From: Leo Torres <ltorres@gdcllc.com>
Sent: Monday, May 09, 2016 11:29 AM
To: Charles Minozzi
Cc: Joseph Dziegelewski
Subject: RE: Last night's ARB
Attachments: 2016-05-09_rendering 1.pdf; 2016-05-09_rendering 2.pdf

From: Charles Minozzi [<mailto:cminozzi@hastingsgov.org>]
Sent: Tuesday, May 03, 2016 10:31 AM
To: Leo Torres; Joseph Dziegelewski
Subject: Last night's ARB

We were surprised not to have representation at last night's ARB meeting for the re-submission for SML. Your case was not officially reviewed for there was no one to present the changes, however there were some comments that the Board felt I should give you a preview of, so next moth you could be more prepared. They do not like the octagonal roof at the BBQ area, they feel it just does not mesh well with the project, maybe a shed roof or something more industrial looking. They do not like the round BBQ area or the round fire pit for the same reasons, again maybe something more squarish or more industrial as well.

1 PROPOSED SITE PLAN
1" = 40'-0"

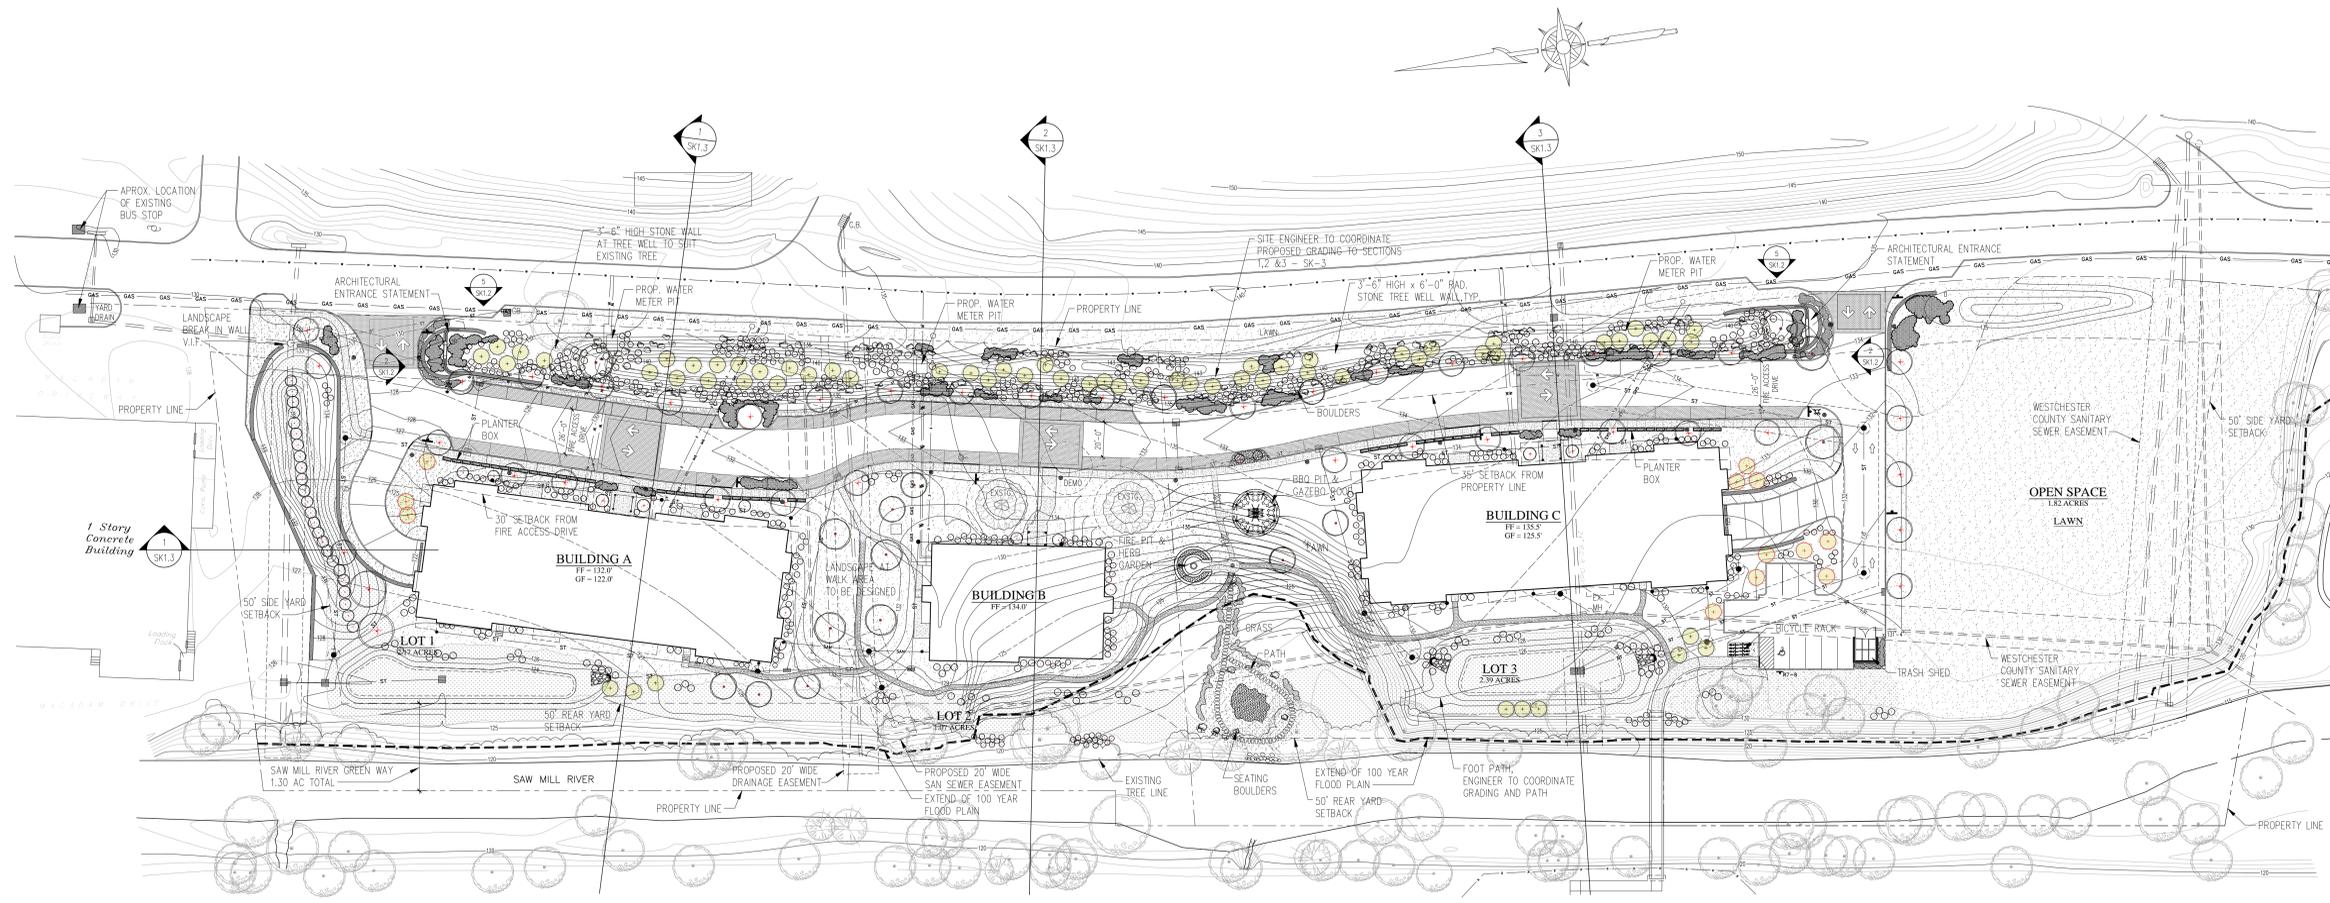
They do not like the cut in the retaining wall, it was supposed to be two by-passing walls.
They do not like the change in materials from the stamped sidewalk to the pavers.
Hope this is helpful.
Thanks B

1. BBQ Pavilion – while we understand the opinion of the board to want this pavilion structure to fit in with the Architecture of the buildings, we feel this is too literal an interpretation of the design. The design as proposed is more informal, friendly, and inviting than, we feel, a square plan would be. This space is meant to be a community gathering space in a garden like setting. The octagonal shape is more conducive to this function and idea of gathering, especially given the garden setting, than a square shape. This pavilion is meant to evoke the idea of gathering of a traditional gazebo whilst paying homage to the adjacent building architecture through its materials and colors. Typically, industrial shed like buildings would be rather ugly and uninviting as they are made to be inexpensive and utilitarian. While we are willing to revise our design if the ARB feels very strongly about their opinions we do feel the building works and will fit in with the buildings, as well as, its garden setting and we, as the designers, are pleased with it. To that end, please find attached revised renderings of the BBQ pavilion with the revised materials and colors. We would ask that the ARB re-consider their opinions as we feel the more modern revisions to the materials and colors is enough to connect this garden pavilion to the other structures.

2. Fire pit – We feel that the ARB's comments are not suitable to the necessary function of this amenity. This amenity functions in-the-round. Typically, people sit around a fire in a circle. We have merely sought to materialize this form with garden seat walls. While we are willing to, and will, facet the circle, we are not willing to square off this site feature. Again, we feel that the ARB's comments are too literal for a garden type feature such as this. This is a site feature and will be seen as such. We strongly do not believe that this site feature must look industrial in an effort to coordinate with the architecture of the buildings. As such, we will agree to facet the circle.

3. Retaining walls – we will modify the site plan as noted below.
4. Sidewalk – We are not sure what this comment refers to. We can discuss this further.
